## FORD A4LD MISSING BEARING RACE

Figure 1

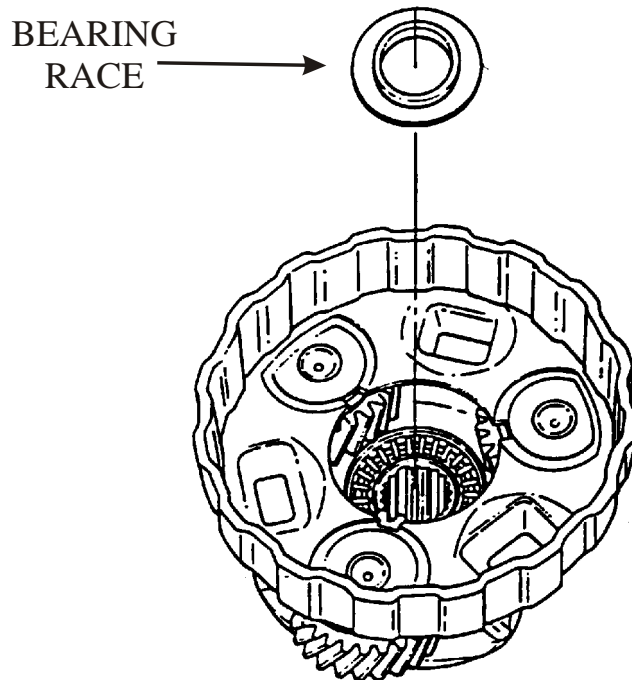
Some overdrive planetary assemblies for A4LD transmissions may be missing a sun gear thrust bearing race. This bearing race is required and should not be omitted. Figure 1 shows the proper location of this race and is available under OEM part number E5TZ-7D235-B
